Access Compliance Report

Public Rights-of-Way

(Curb Ramps)

Intersection ID: 48791	Main Street: HARDWOOD_WATCH_CT	Cross Street: WOODLAND_WATCH_CT	Location: SE
ADA ID: E2A81EA44CC1	Ramp Type: Perp	Initial Pass/Fail: Fail	Overall Compliance: No
Severity Score: 10			
Codes/Mitigation Info/Possible Solution		Field Measurements/Component Compliance

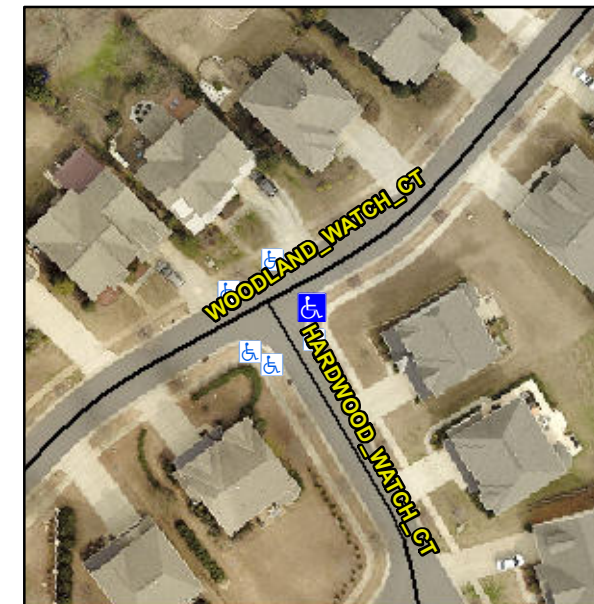
Not Found, R304.5.1, R304.5.3

Compliance	Description	Data	Compliance	Description	Data
N/A	Ramp Length (in)	71.0	Yes	Ramp Slope (%)	6.2
No	Ramp Width (in)	36.0	No	Ramp XSlope (%)	2.2
N/A	Flare Type LT	N/A	N/A	Flare Type RT	N/A
N/A	Flare Slope LT (%)	N/A	N/A	Flare Slope RT (%)	N/A
N/A	Flare Traversable LT?	N/A	N/A	Flare Traversable RT?	N/A
N/A	Landing Length (in)	N/A	N/A	DWS Provided?	N/A
N/A	Landing Width (in)	N/A	N/A	DWS Contrast?	N/A
N/A	Landing Slope (%)	N/A	N/A	DWS Length (in)	N/A
N/A	Landing X Slope (%)	N/A	N/A	DWS Full Width?	N/A
N/A	Landing Curb? (Y/N)	N/A	N/A	DWS Offset (in)	N/A
N/A	Shared Landing?	N/A			
N/A	Gutter Ponding?	N/A	N/A	Gutter Slope (%)	N/A
N/A	Gutter Lip Ht (in)	N/A	N/A	Gutter X Slope (%)	N/A
N/A	Painted X Walk1?	No	N/A	Painted X Walk2?	N/A
	X Walk 1 Direction	To NW		X Walk 2 Direction	N/A
N/A	X Walk 1 Width (in)	N/A	N/A	X Walk 2 Width (in)	N/A
	X Walk 1 Slope (%)	3.0		X Walk 2 Slope (%)	N/A
	X Walk 1 X Slope (%)	0.4		X Walk 2 X Slope (%)	N/A

Remove & Replace Entire Ramp.
